February 28, 2020

**Subject: Action ID No. SAW-2019-01155 (Town of Sunset Beach)  
Maintenance Dredging of S. Jinks Creek, Bay Area, and Feeder Channel  
Response to USACE January 31, 2020 Request for Additional Information**

Figure 1. DCM Shoreline Migration Rates for the east end of Sunset Beach (1981-2016)

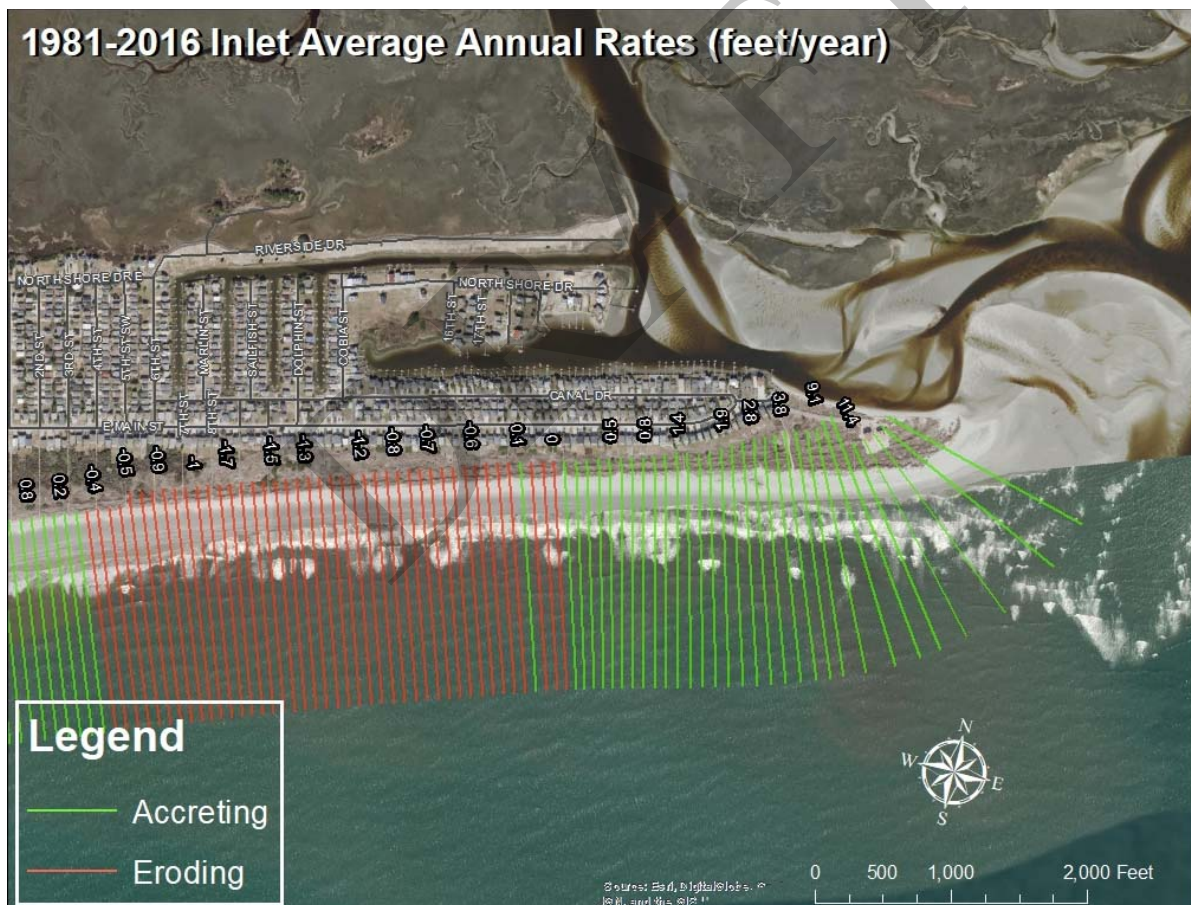
**Purpose and Need:** *“Please provide additional data to support the claim of need for the beach front placement.”*

Therefore, the Town of Sunset Beach identified the area of most need within the littoral system boundaries, and closest to the proposed project to place the beach compatible material. Figure 1 below, provided by Ken Richardson with the North Carolina Division of Coastal Management (DCM), demonstrates the proposed beach placement site as eroding between 1981 and 2016. Please note, the Town did not use this shoreline change data to determine the beach placement site, but the data corroborates their decision.

Based on the comments received from the beach front property owner's, the Town intends to move the beach placement site to a more publically acceptable site. This may include, among other options, material placement on an accreting shoreline, placement on OIB, or truck hauling to an alternate beach
